Project: WEBSTER UNIVERSITY INTERDISCIPLINARY SCIENCE BUILDING
Customer: PARIC CORPORATION
Owner: WEBSTER UNIVERSITY
Location: WEBSTER GROVES, MO 63119
Dwn: TLI Date: 05/23/2016 Ckd: LJ Date: 05/30/2016
Job No. A16013 BAT: DWG#: E2A

SUBMITTAL IDENTIFICATION SHEET

SHOP DRAWING / SUBMITTAL REVIEW

- ☐ NO EXCEPTION TAKEN
☒ EXCEPTIONS NOTED, RESUBMITTAL NOT REQUIRED
- ☐ REJECTED
☐ REVIEWED FOR INFORMATION ONLY
- ☐ REVISE AND RESUBMIT AS NOTED

ONE - COLUMN ~ 210A

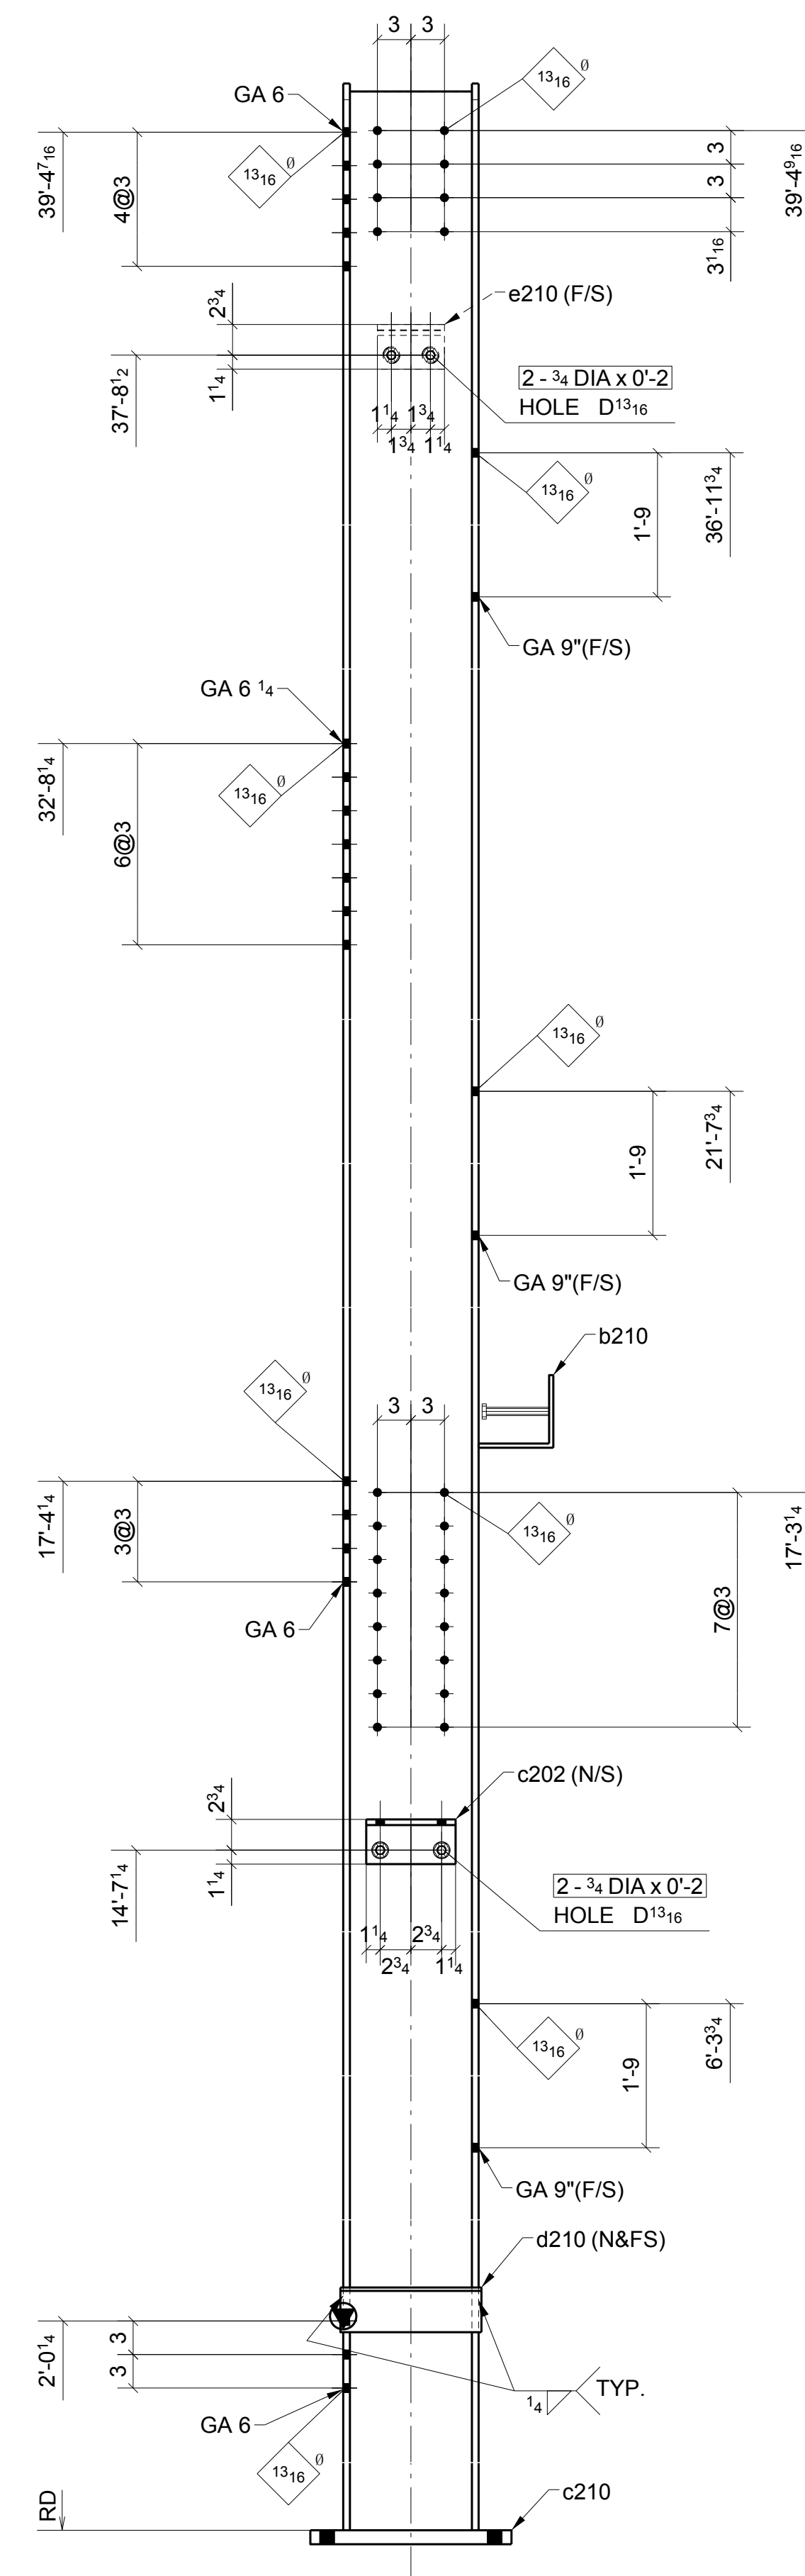
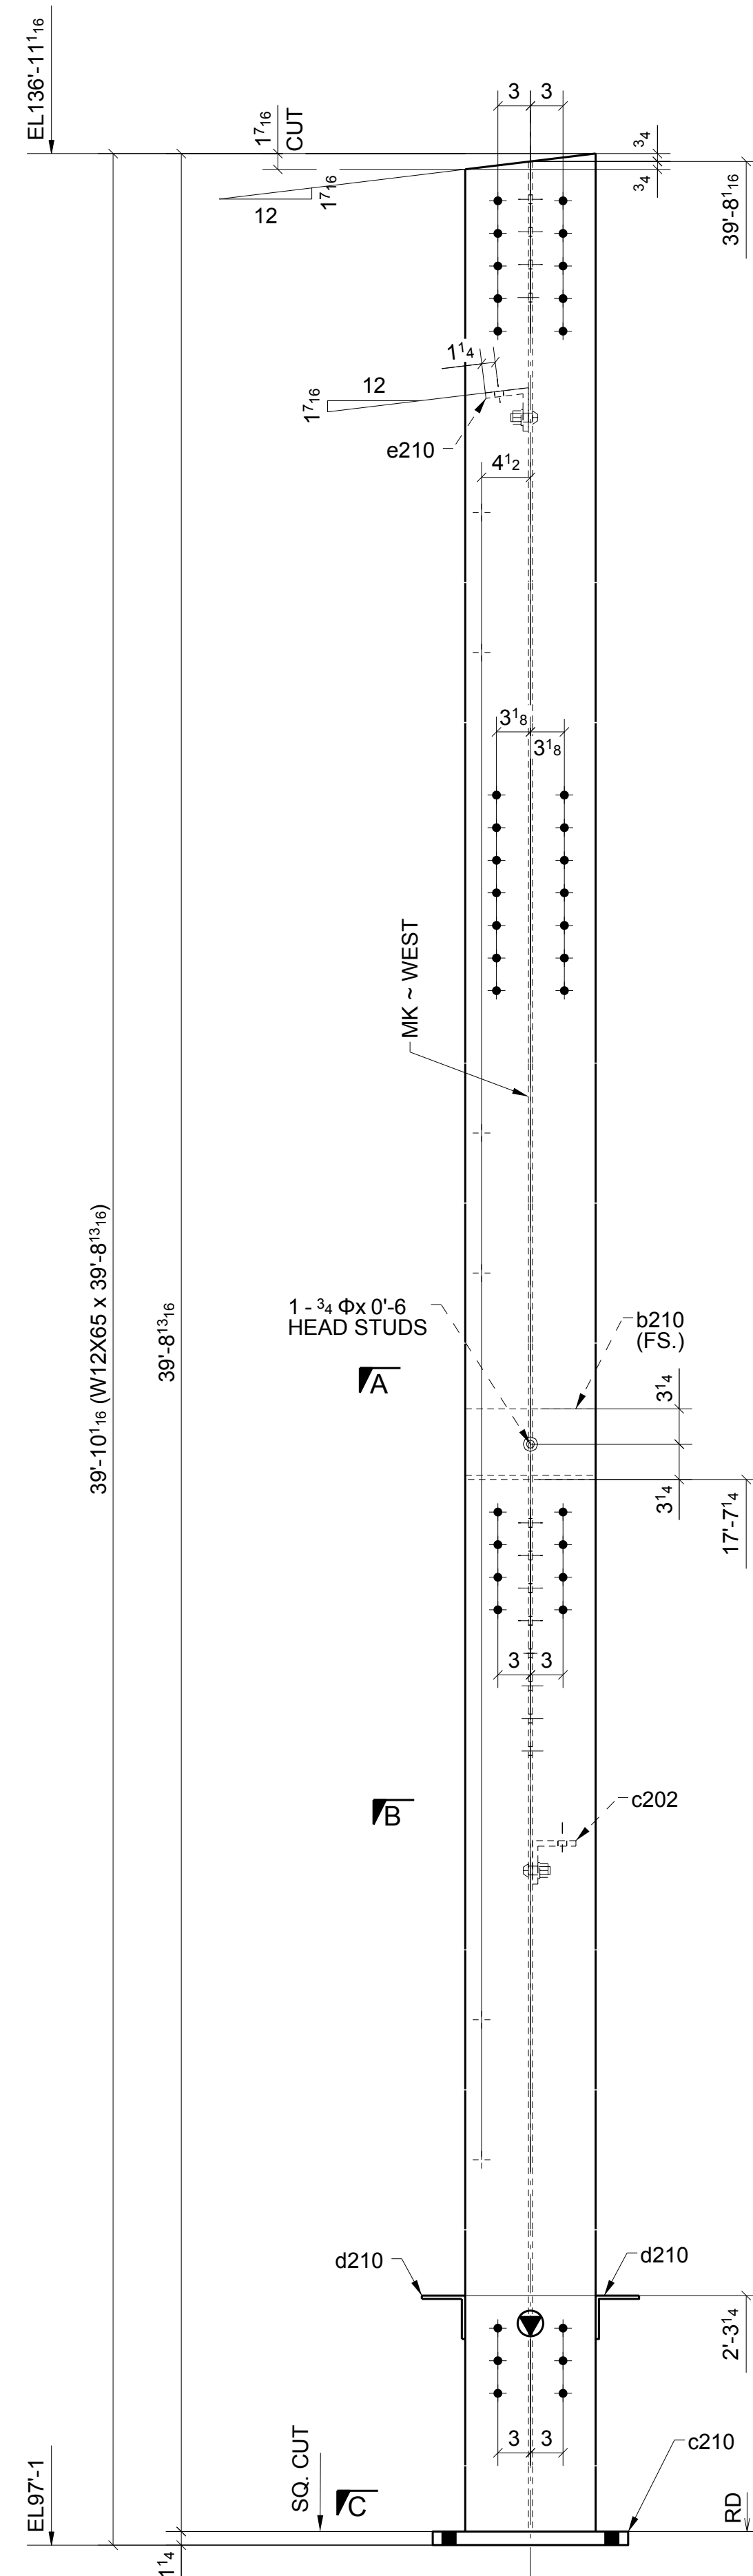
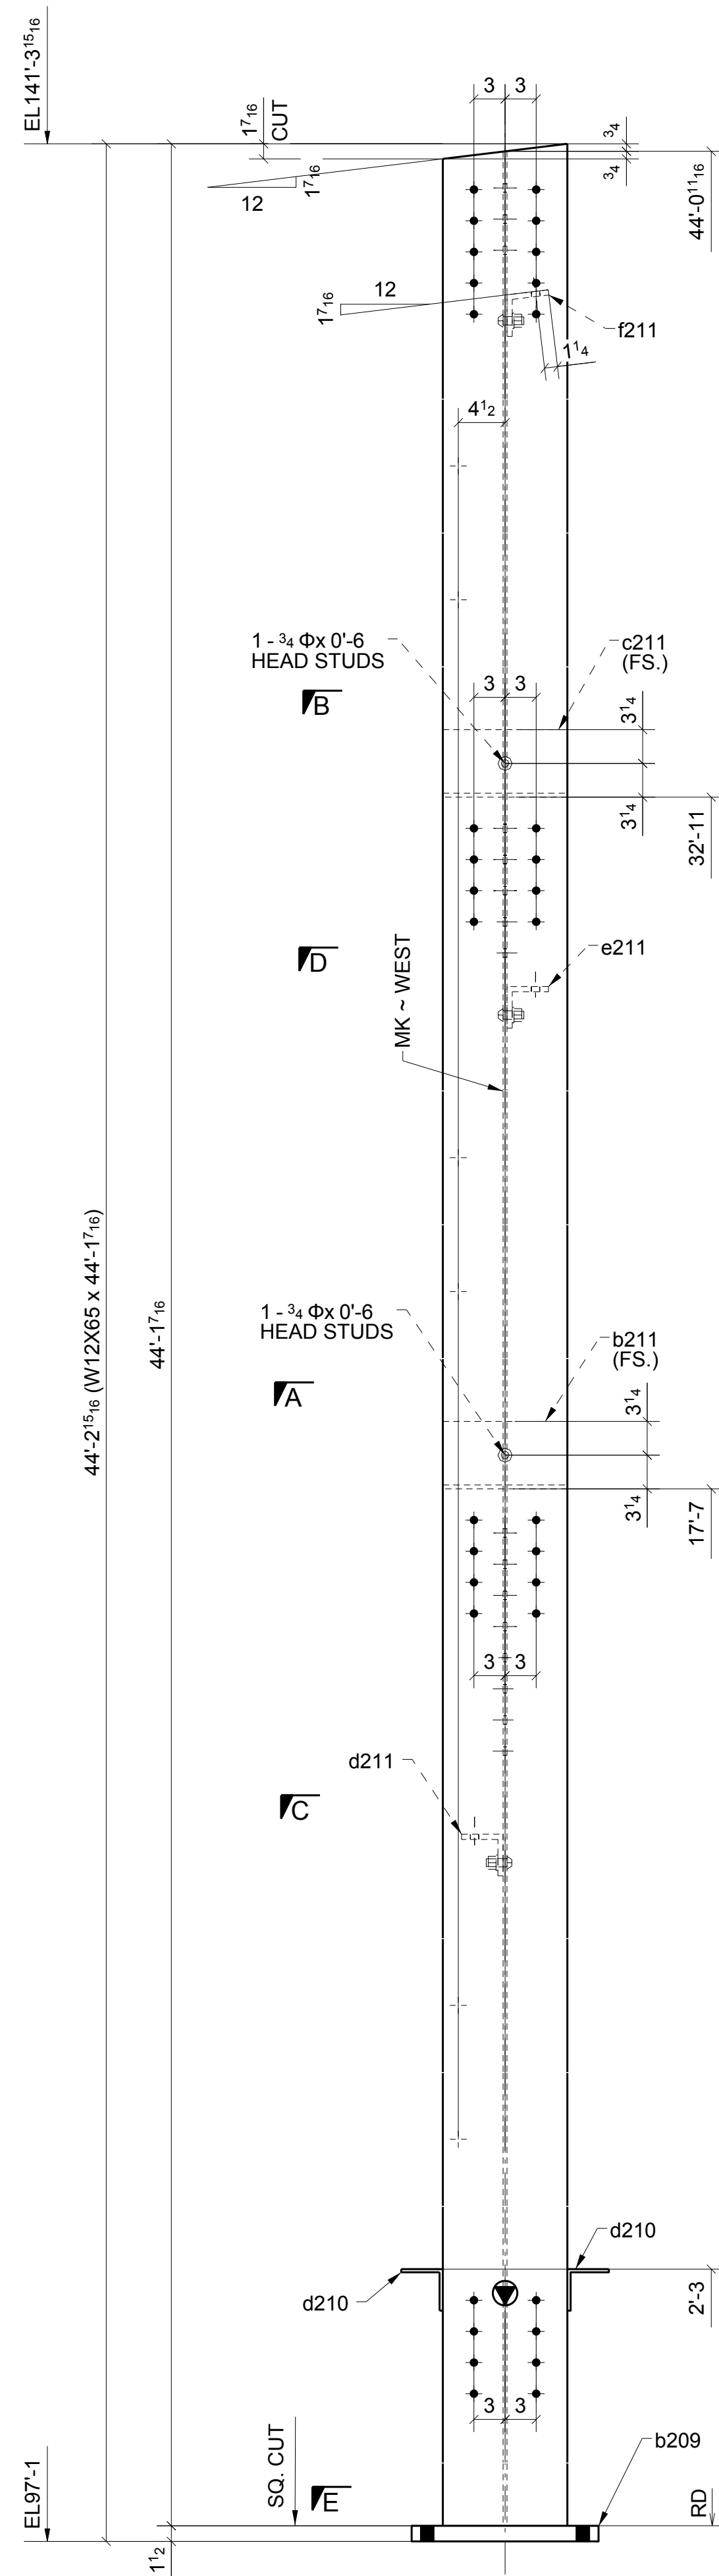
SHOP BOLT IN SLOTTED HOLE
NEED "HAND TIGHTEN"
